Technical Analysis and Findings
Utah Coal Regulatory Program

PID: C0070005
TaskID: 4684
Mine Name: SKYLINE MINE
Title: ABANDONMENT OF WATER MONITORING WELLS

Well 91-26-1

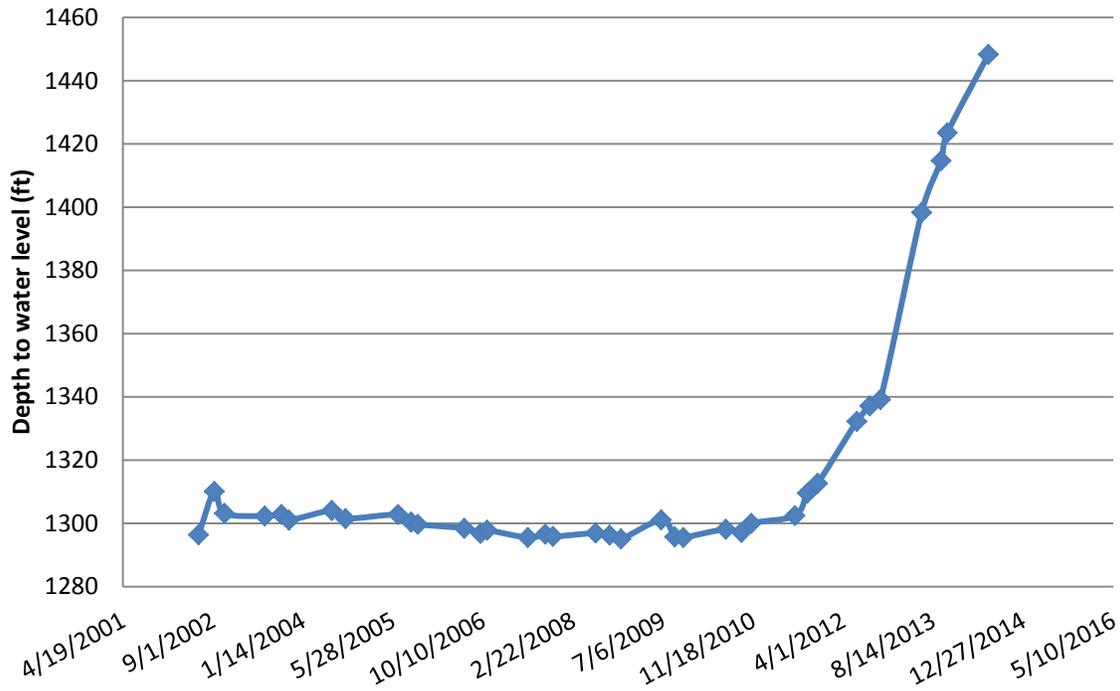
Well W91-26-1 has been monitored since June of 2002 and has reported a depth to water of about 1300 feet from 2002 until late 2012 when the water level has been dropping quickly. The latest water level, taken in June of 2014 indicated a depth to water level as 1448 feet. This is a drop of almost 150 feet in two years, when the water levels only fluctuated about 15 feet over the previous ten years.

Well 91-35-1 was the closest monitoring well to W91-26-1 until it became blocked in 2012, but for about two years prior to becoming blocked, it was also seeing a water level drop.

The Permittee should establish additional monitoring well/wells to observe water level trends in the north lease area. New wells should be drilled as close to previously monitored wells as possible, and screened in the same geologic formation.

Figures 1 and 2 attached to the permit amendment report display depth to water level fluctuations in wells 91-26-1 and 91-35-1.

R645-301-731.214 Water monitoring wells 91-26-1 and 91-35-1 are the only groundwater monitoring wells located within the North Lease. Well 91-26-1 provided ten years of consistent groundwater levels before the levels began dropping in 2012. The groundwater levels in this well appear to be still be dropping. Well 91-35-1 was the closest monitoring well to 91-26-1 prior to it becoming blocked. A new water monitoring well should be established to continue monitoring groundwater
